Manual Supplement

Manual Title:	Service Manual PM3370B/8xB/9xB	Supplement Issue:	4
Part Number:	4822 872 05372	Part Number:	4822 872 08566
Print Date:	15-June-1997	Issue Date:	19-April-2002
Revision/Date:	-/-	Page Count	15

This supplement contains information necessary to ensure the accuracy of the above Service Manual. The following items have been added:

Figure 1. Large component side of XYZ amplifier unit A2 – 100 MHz

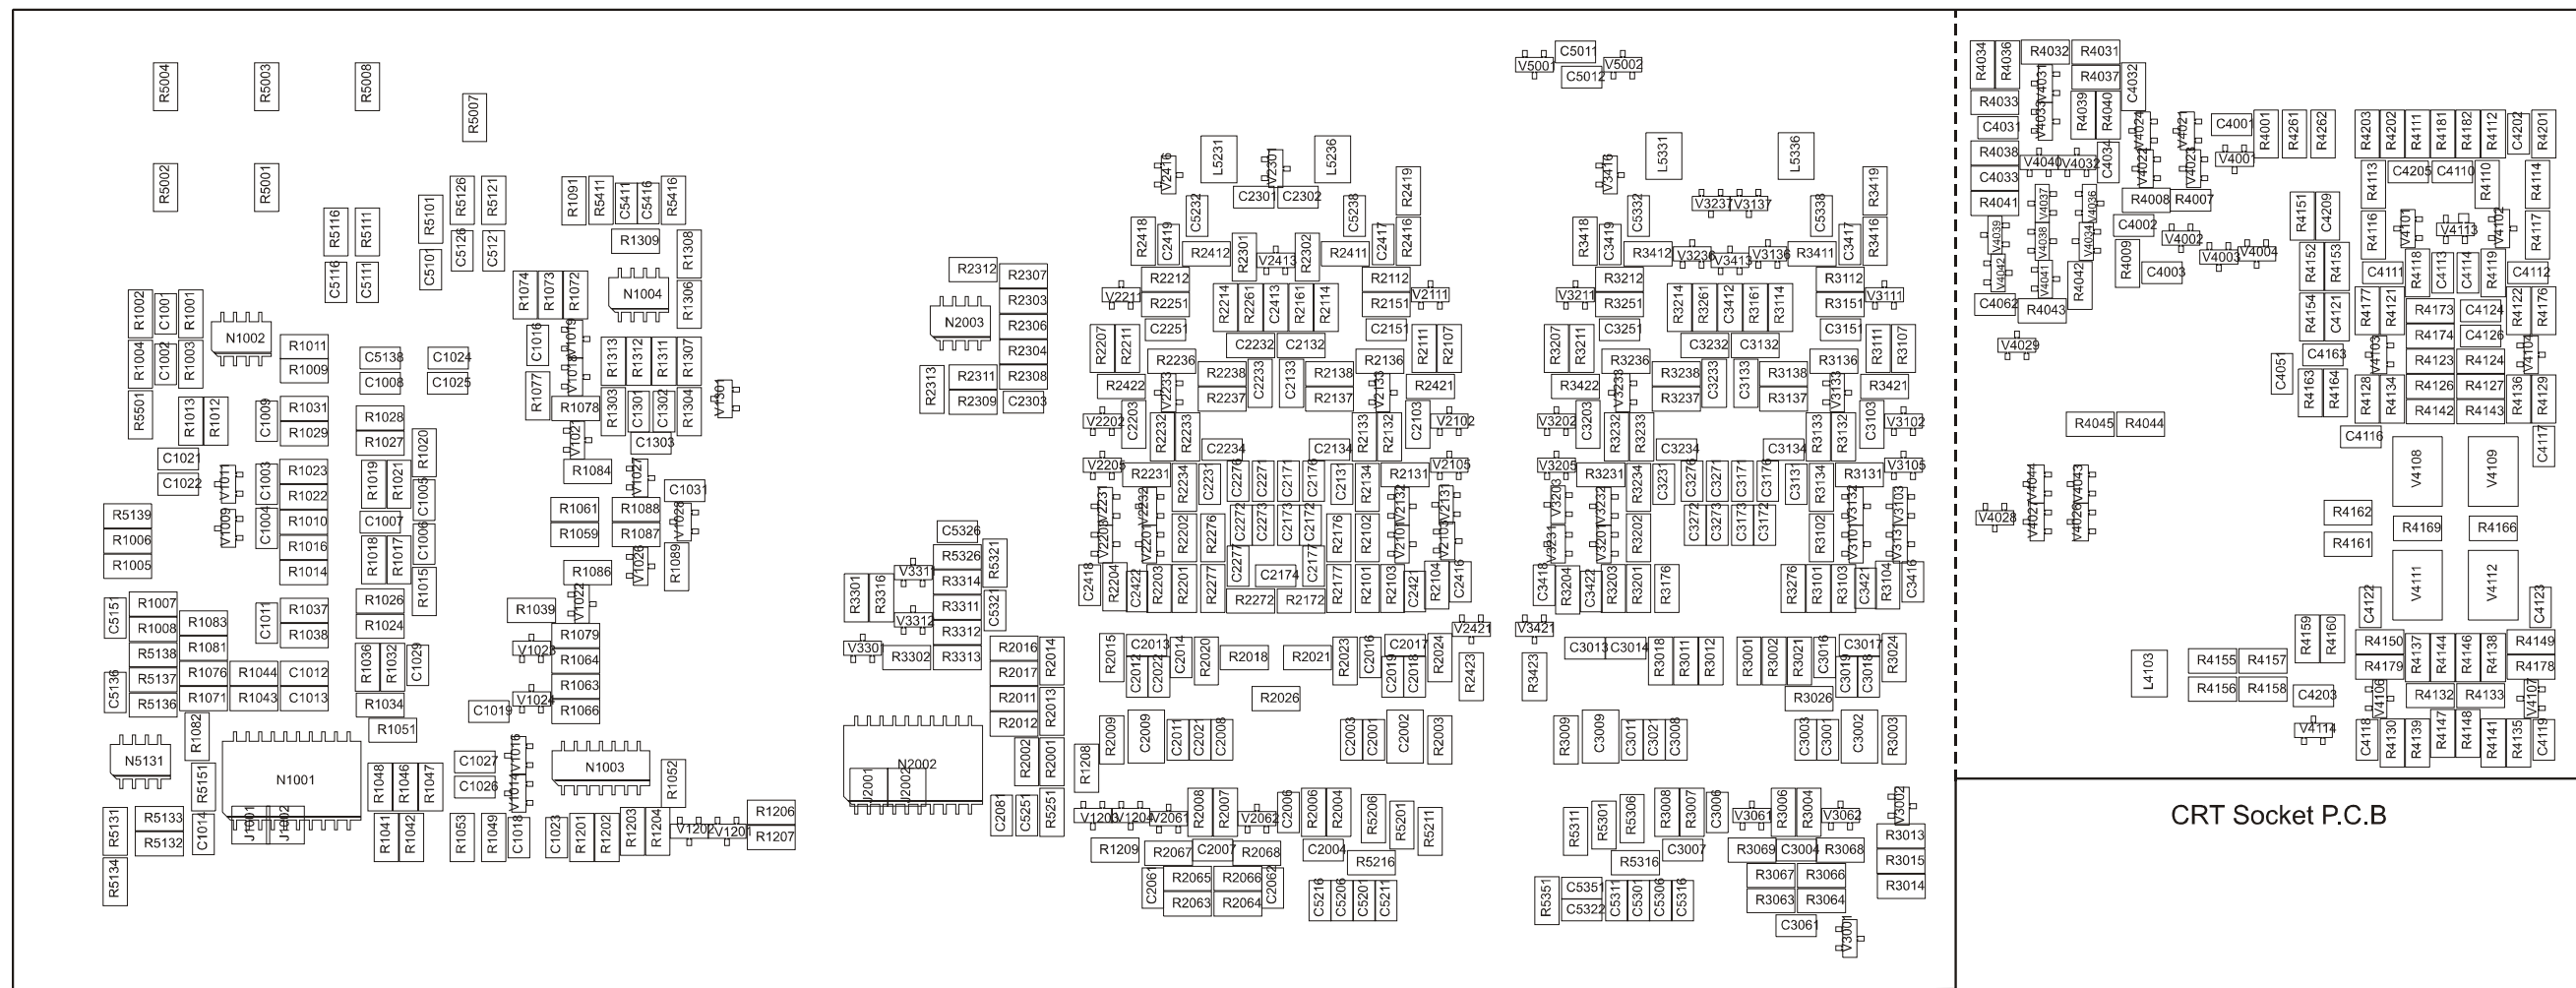
The large component side and the small component side are shown in the Figure 1 and 2. The circuit diagrams and parts lists in the Service Manual are correct. The XYZ-amplifier with .5 layout has been introduced in scopes with serial numbers DM738xxx and onwards. A 12-digit ‘manufacturing’ code ending with .5 is present on the edge of the PCB. The code is readable with the amplifier mounted in the scope’s chassis. The service ordering code 5322 216 04243 of the XYZ-amplifier is not changed.

Figure 3. Large component side of XYZ amplifier unit A2 – 200 MHz

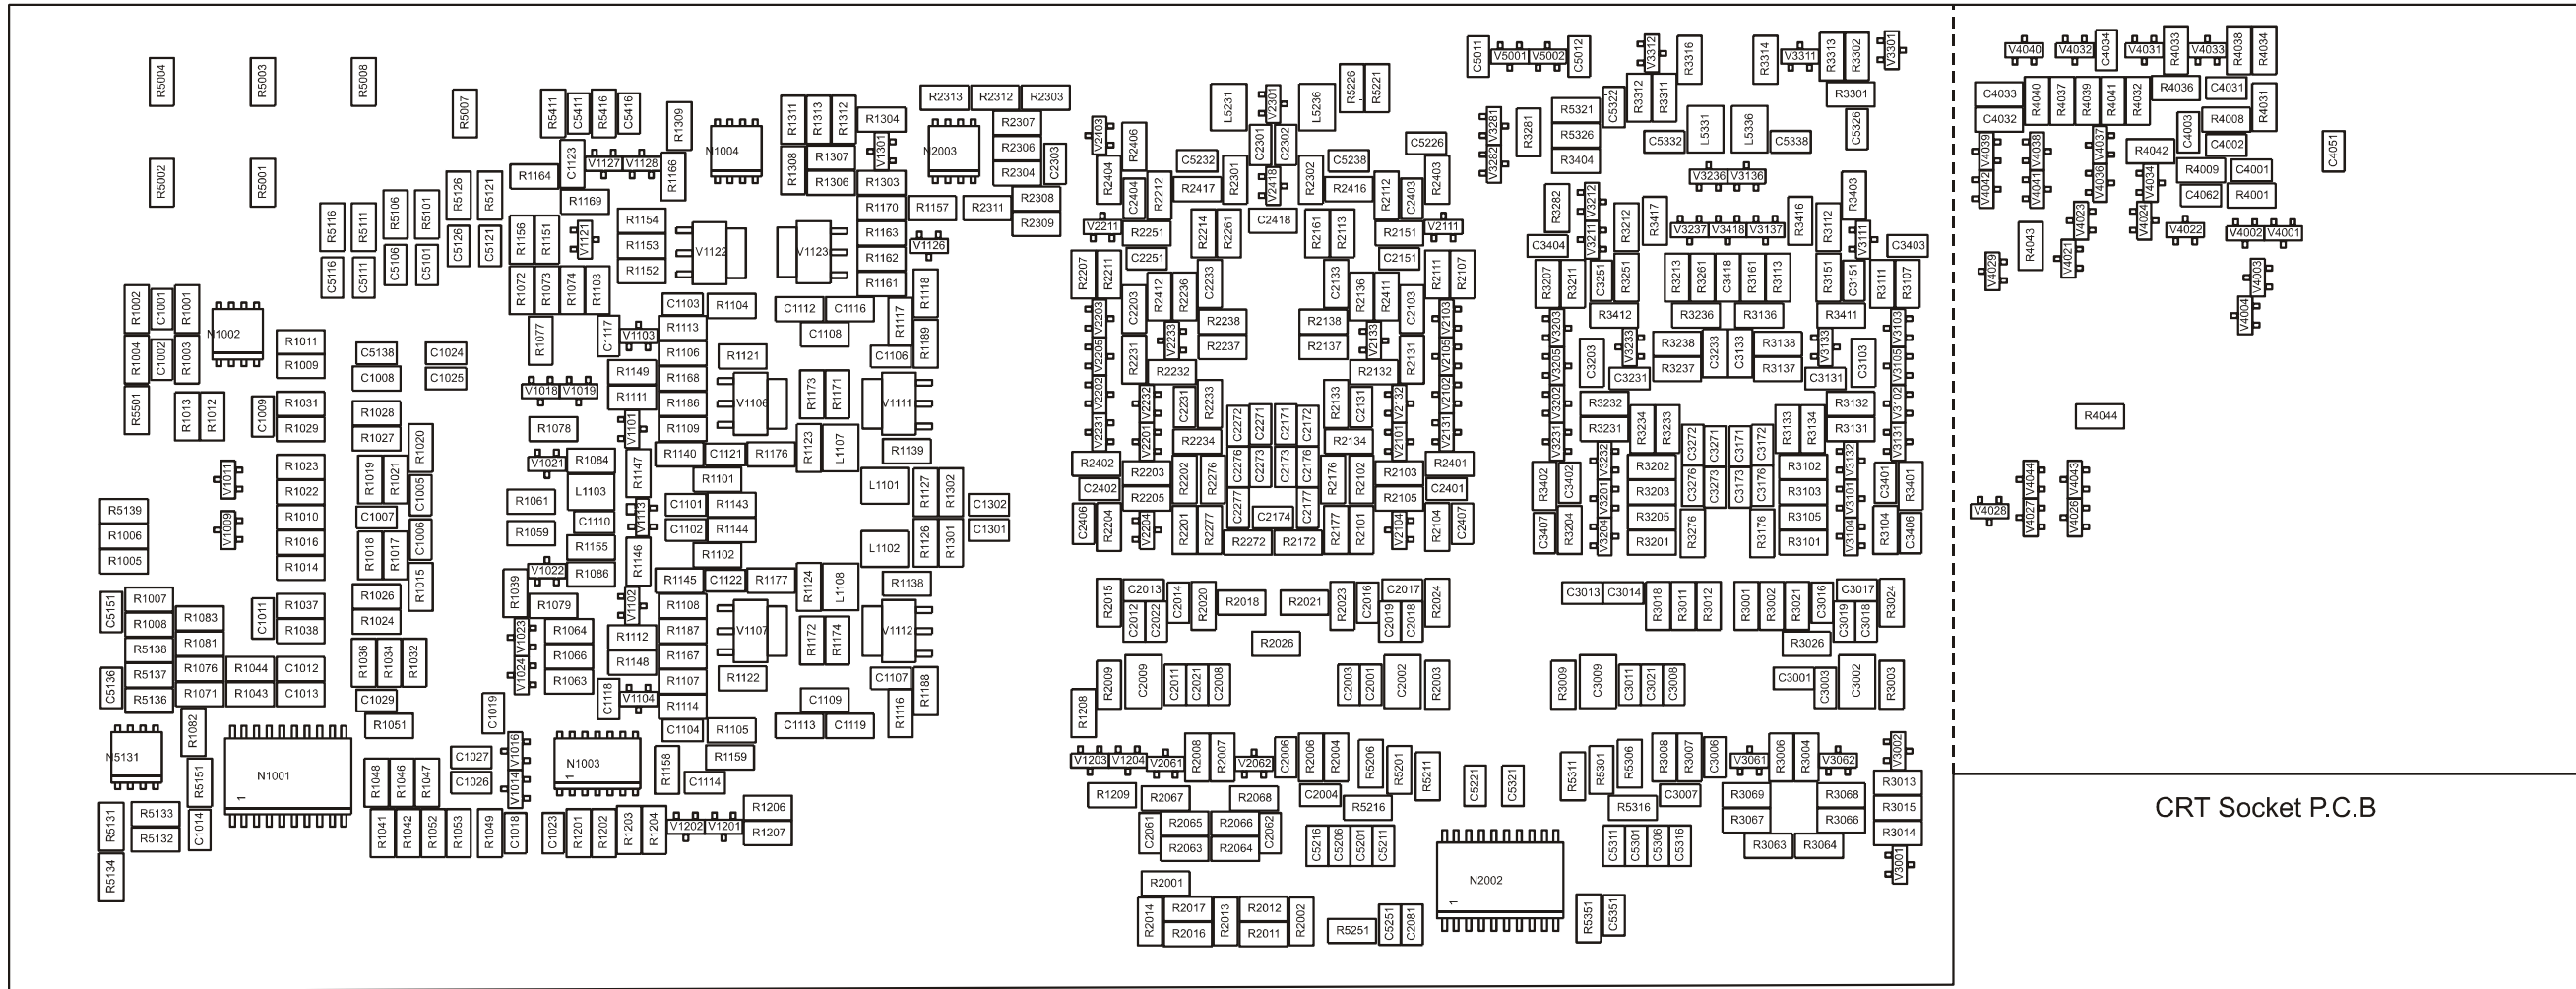
The large component side and the small component side are shown in the Figure 3 and 4. Changes in the circuit diagrams and parts lists are described below. The changes are mainly introduced to optimize HF square wave response. Circuit diagrams that have changed considerably are shown in this supplement. The XYZ-amplifier with .5 layout has been introduced in scopes with serial numbers DM698xxx and onwards. A 12-digit ‘manufacturing’ code ending with .5 is present on the edge of the PCB. The code is readable with the amplifier mounted in the scope’s chassis. The service ordering code 5322 216 04244 of the XYZ-amplifier is not changed.

Figure 7. XYZ amplifier 200 MHz – Diagram 5, Modulator/demodulator and focus control

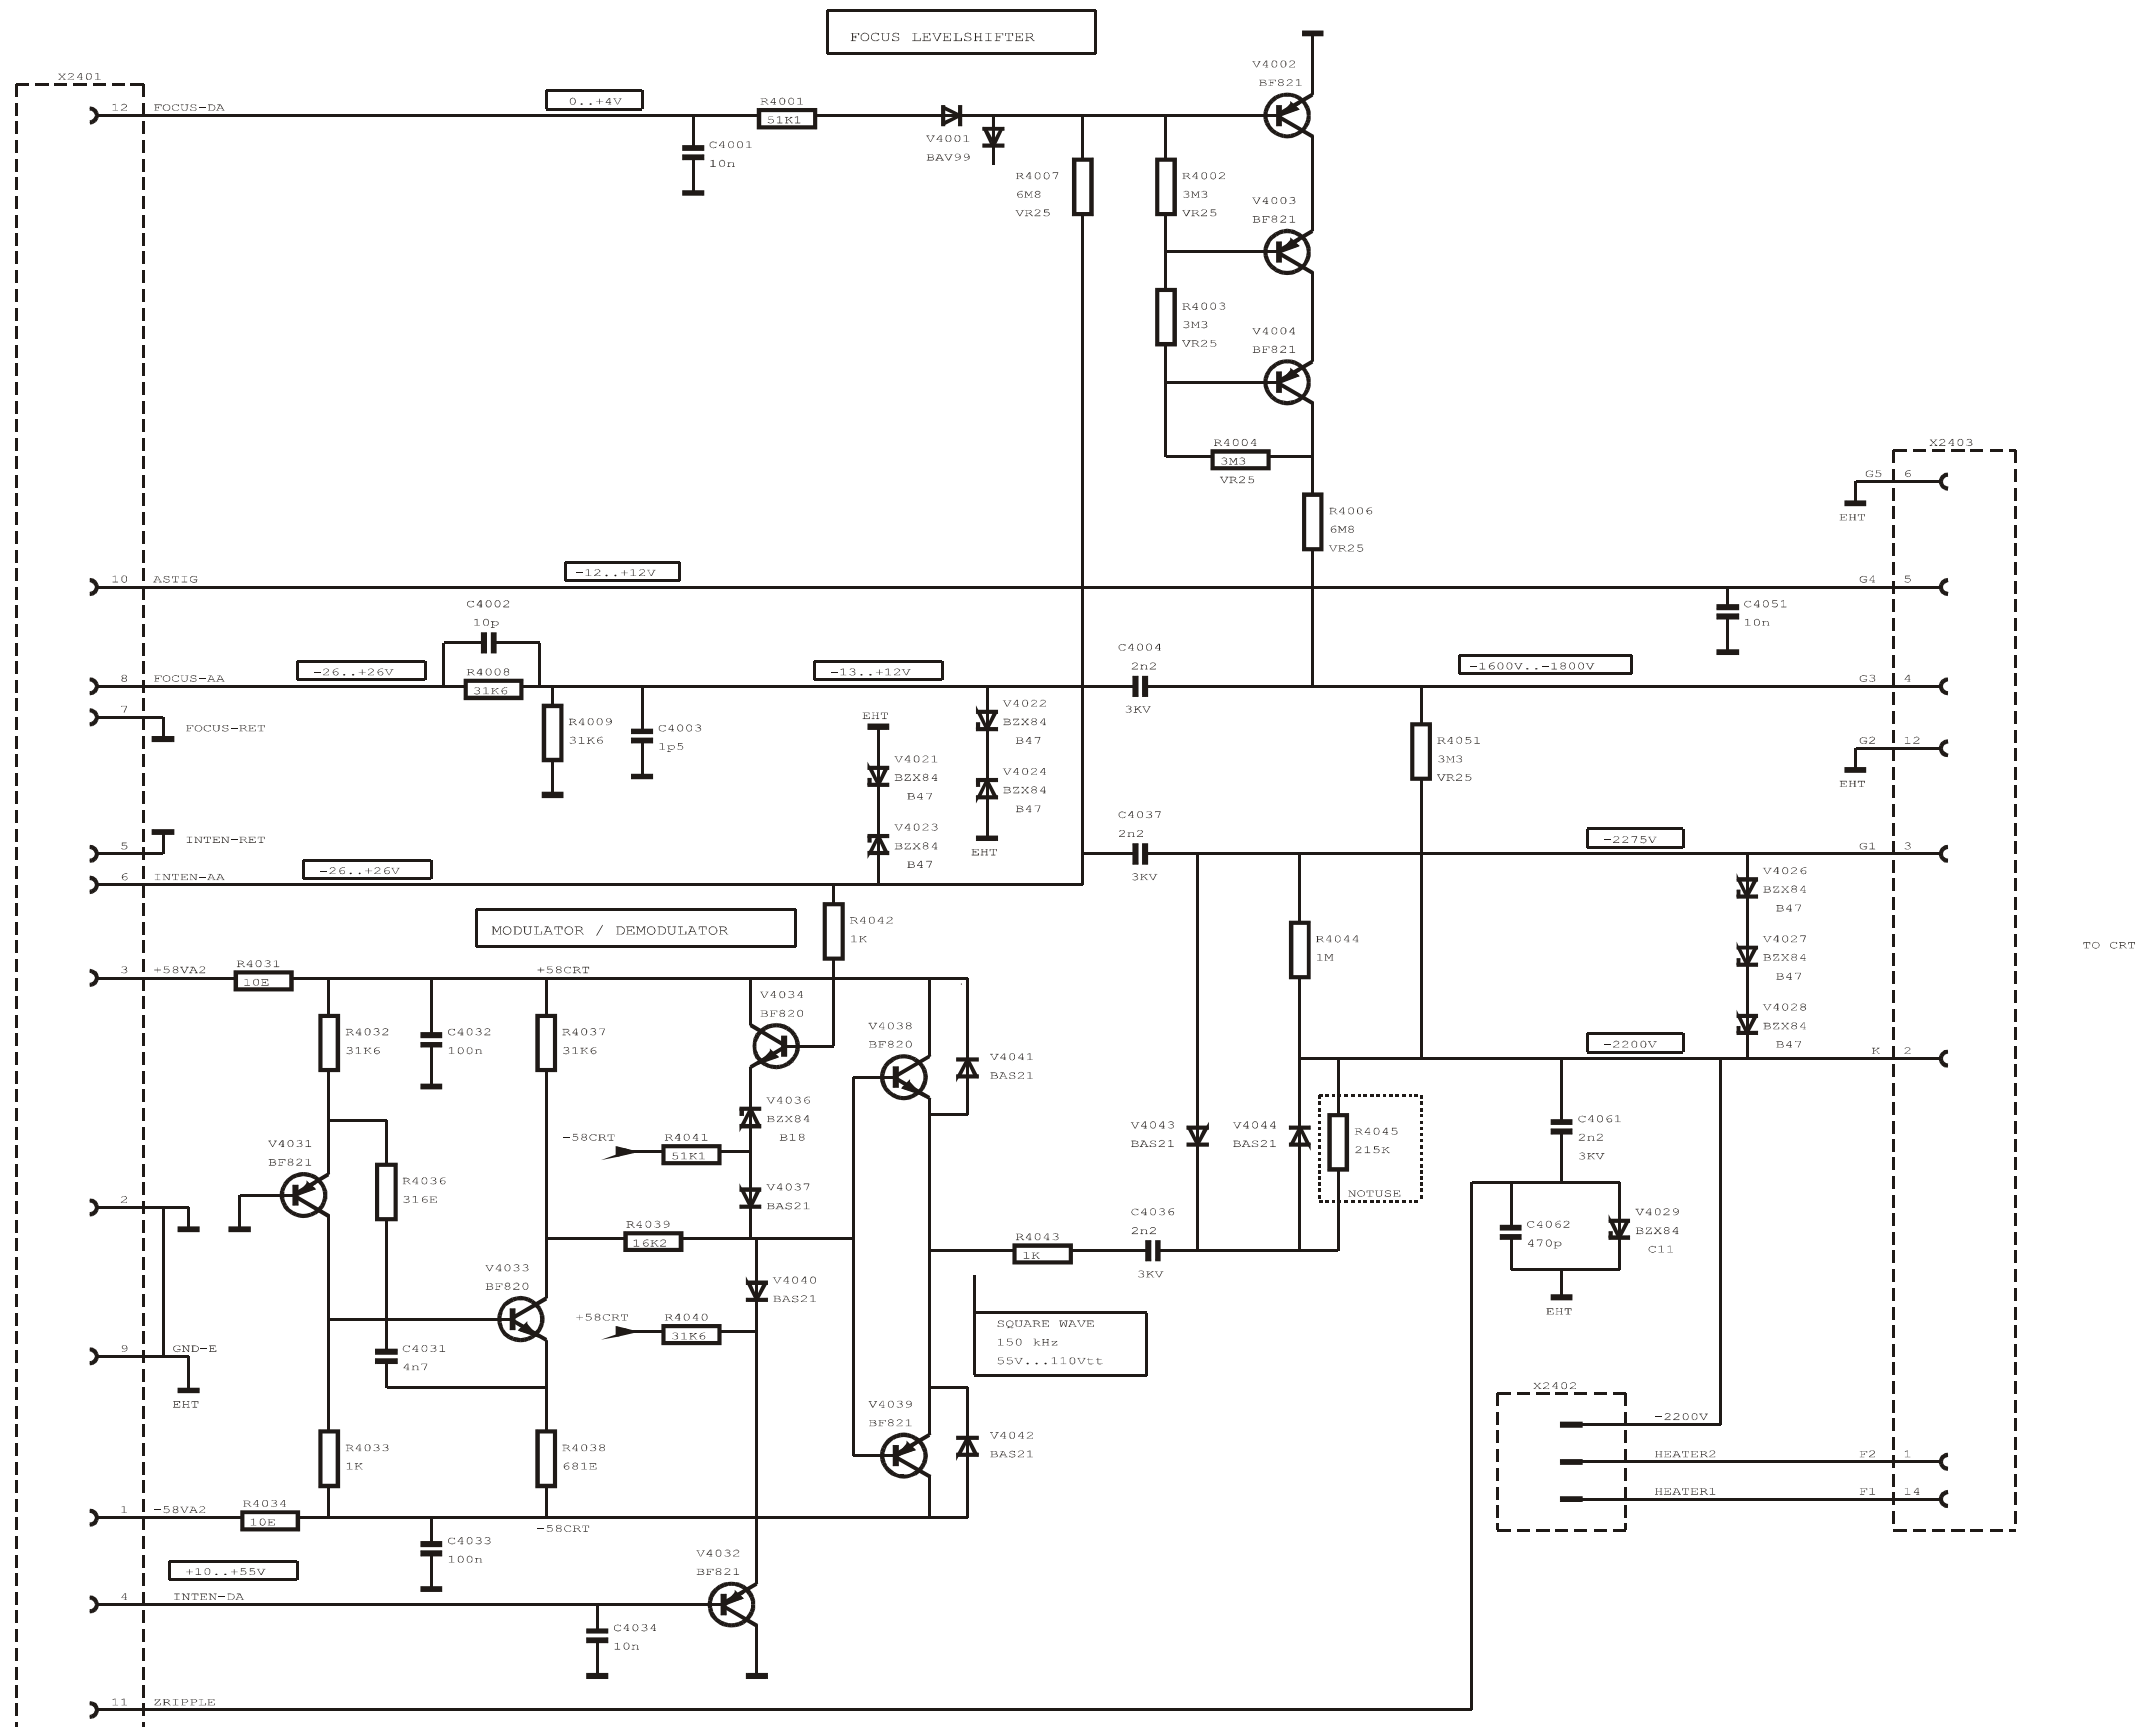
Circuit diagram 5 (Refer to Figure 7 in this publication):

A zenerdiode BZX84-C11 (part nr. 4822 130 81338) is added in parallel with C4062. The diode has itemnumber V4029 and its cathode is connected to ground)

A series circuit consisting of 2 zenerdiodes BZX84-B47 (part nr. 4822 130 82521) is added. The cathodes of the zeners are connected together (thus in opposite direction). The anode of one zener (V4023) is connected to INTEN-AA; the anode of the other zener (V4021) is connected to ground.

A series circuit consisting of 2 zenerdiodes BZX84-B47 (part nr. 4822 130 82521) is added. The cathodes of the zeners are connected together (thus in opposite direction). The anode of one zener (V4022) is connected to junction C4003/C4004; the anode of the other zener (V4024) is connected to ground.

A series circuit consisting of 3 zenerdiodes BZX84-B47 (part nr. 4822 130 82521) is added. These zeners V4026, V4027, V4028 are connected anode to cathode; they all have the same direction. The anode of V4026 is connected to G1/X2403-3. The cathode of V4028 is connected to K/X2403-2.
